City of Madison, Wisconsin

REPORT OF: URBAN DESIGN COMMISSION

3520 & 3546 East Washington Avenue – New Auto Service Station with Detached

Car Wash and Convenience Store for "PDQ" in UDD No. 5. 15th Ald. Dist.

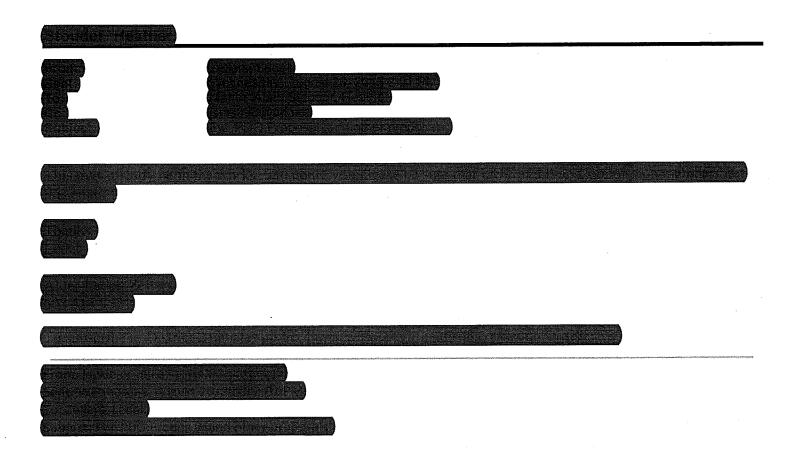
The driveway on east wash is still too small. With the way the parking is now shown on page 12 of the rewrite... everyone is going to exit Schmedemann. It makes the most sense as that's the majority of the parking. This also means that super long delays at the corner of Schmedemann and East Wash. It's already challenging to make a turn at that corner and this is going to make it 1000 times worse. Therefore, REGULARS... will learn that they can take a left instead and cut through the neighborhood and go out to Rowland, Graceland to Straubel or circle back and around over to Riendahl. Anyone who's a regular will learn and then you have monkey see, monkey do syndrome. So over time, others will catch on as well. This is bad.

Secondly, the fence... it no longer comes all the way out to Schmedemann. Therefore they are putting the pedestrian access back into the picture. That was one of the primary concerns for all of us. It will encourage foot traffic, which PDQ wants, but the residents do not want. IT will mean increased noise at all hours of the night and it means a significant increase in trash as people buy their food and dump it on their way home.

Third... the RED NEONS that go all the way around the canopy and the store, will forever be turned on. 24x7. At night, a red glow will be everywhere. In their drawings they show 6 or 7 new homes built behind the lot along Ridgeway. Well... that's "Future" and also "best scenario". It could be decades or never... before those appear and act as a buffer between this lot and Ridgeway residents. I believe that this red glow will impede on the quality of life for all parties concerned.

I believe the lack of a fence coming all the way up to Schmedemann and then around the corner back towards East Washington will also impede the quality of life for everyone living on the corner of Schemedemann and Ridgewood Ave.
